SUBJECT: THREE MILE ISLAND UNIT 1 - TRANSMITTAL OF TECHNICAL
EVALUATION REPORT ON THE OFFSITE DOSE CALCULATION MANUAL
(TAC NO. M82167)

TECHNICAL EVALUATION REPORT FOR THE EVALUATION
OF ODCM REVISION) (MARCH 1991) THREE MILE
ISLAND NUCLEAR STATION, UNIT 1

NRC Docket No. 50 289

Figure 1. Liquid effluent release routes at TMI-1. (Reproduced from Figure 1.2 of the TMI-1 ODCM, Revision 0, effective March 20, 1991.)

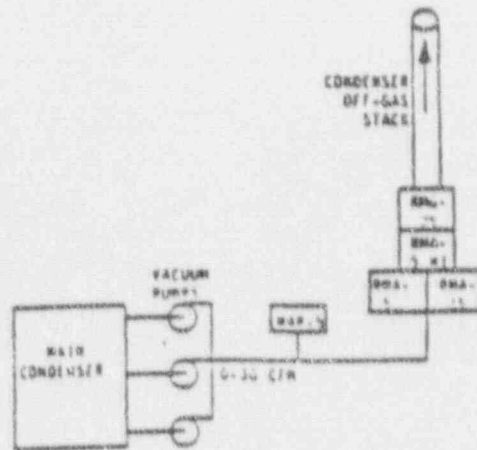
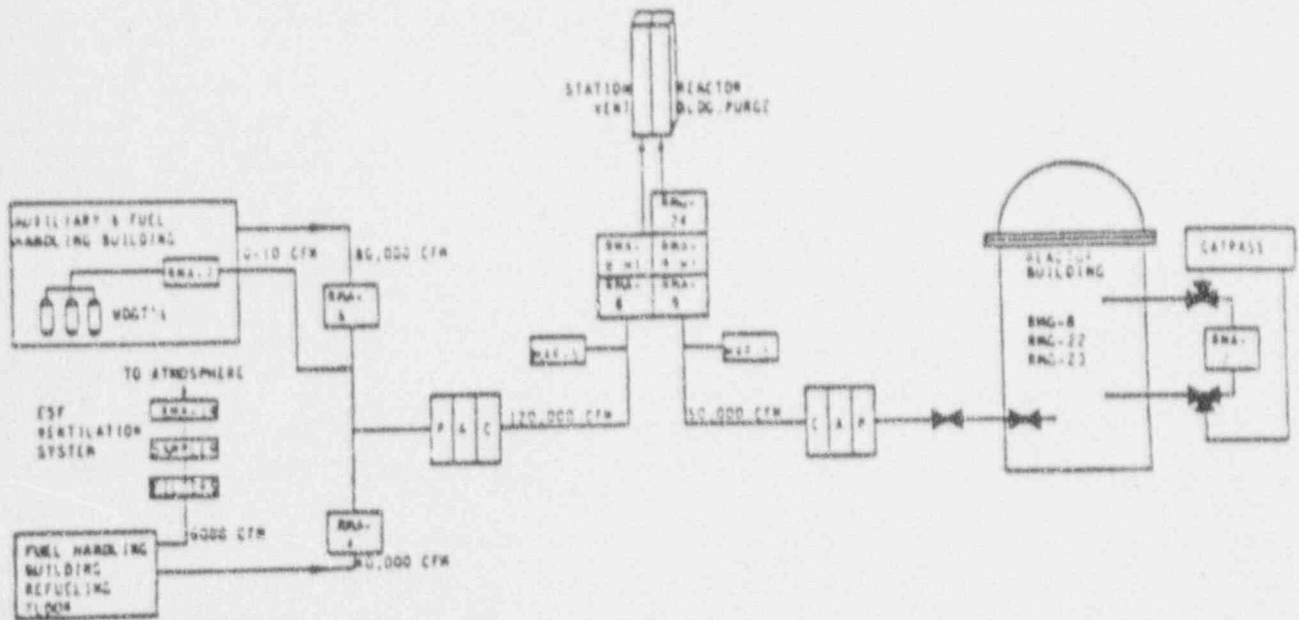
Section 1.2.3 of the ODCM also requires a monitor on the Turbine Building Sump (RM-L10), which is not required by the technical specifications. These monitors are shown in Figure 1 (duplicated from Figure 1.2 of the ODCM). In this figure the monitors are labeled RML-6, RML-10, and RML-12, respectively, instead of RM-L6, RM-L10, and RM-L12.

Information given in the ODCM concerning the flow rate of dilution water (F) is incomplete or confusing. ODCM Figure 1.2 shows effluents monitored by RM-L6, RM-L10, and RM-L12 being released at the same point. However, the on-site dilution given in ODCM Table 1.2 for effluents monitored by RM-L6, RM-L10, and RM-L12 are, respectively, 5000 gpm, 15,000 gpm, and 15,000 gpm. This apparent discrepancy should be explained or corrected.

6. The right side of Equation 5.2.2 should contain a summation over dose pathways. (3.8.3)
7. For consistency with Section 1.2 of the ODCM and Technical Specification 3.2.1.1, the liquid effluent monitors shown in Figure 1.2 should be labeled RM-L6, RM-L10, and RM-L12, respectively, instead of RML-6, RML-10, and RML-12. (3.1)

Figure 2. Gaseous effluent release routes at TMI-1. (Reproduced from Figure 4.3 of the TMI-1 ODCM, Revision 0, effective March 20, 1991.)

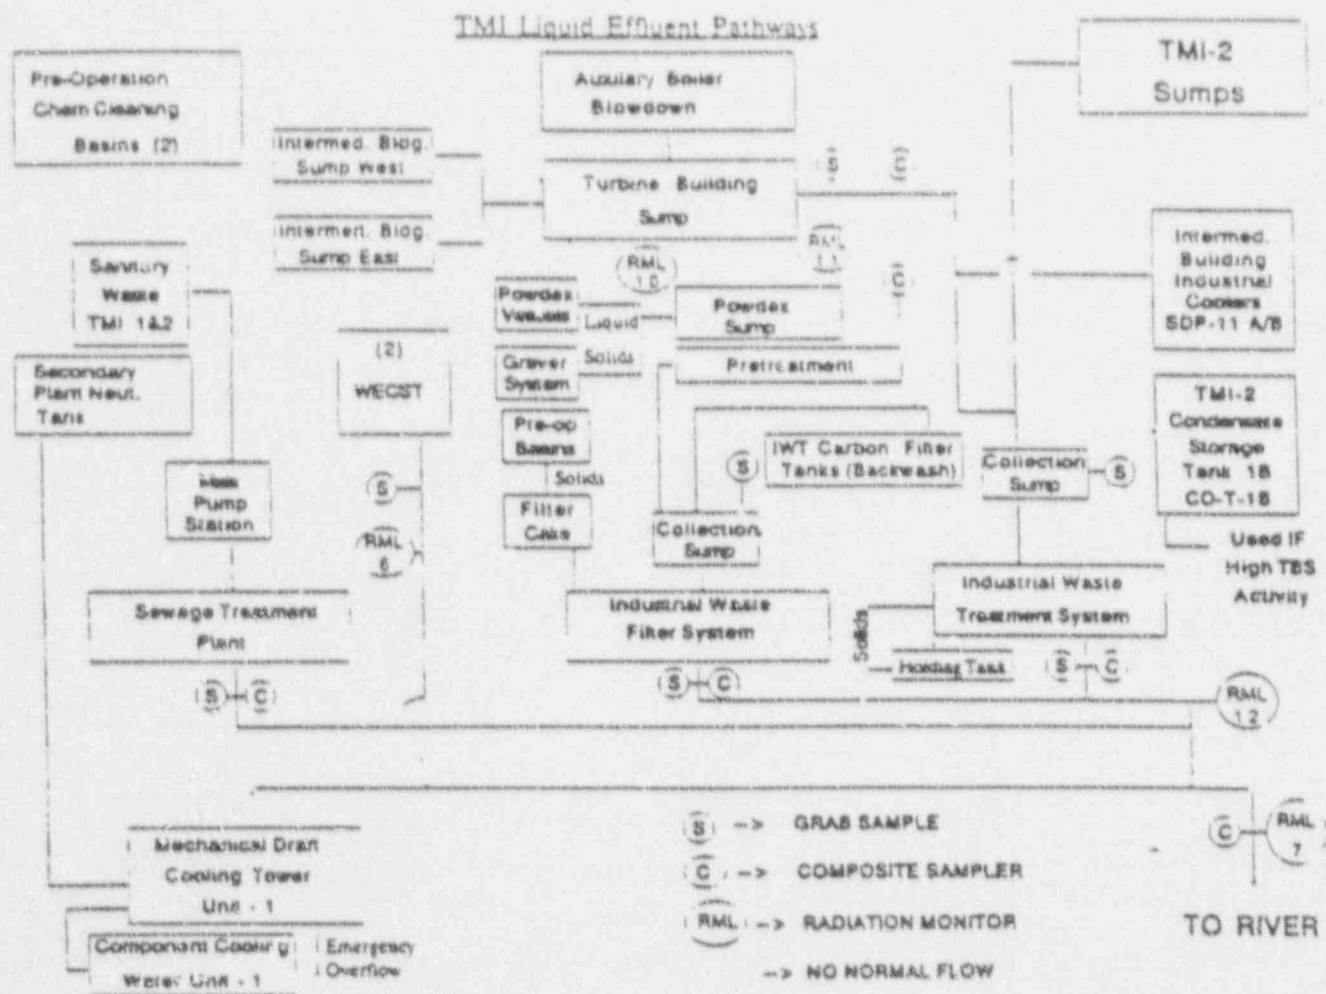
The release routes and radioactivity monitors are shown in Figure 2 (duplicated from Figure 4.1 of the ODCM). In this figure the monitors are labeled using RMA-7 instead of RM-A7, RMA-9 instead of RM-A9, etc.

8. For consistency with Section 4.3 of the ODCM and Technical Specification Table 3.21-2, the gaseous effluent monitors in ODCM Figure 4.1 should be labeled RM-7, RM-9, ..., respectively, instead of RMA-7, RMA-9, (3.3)
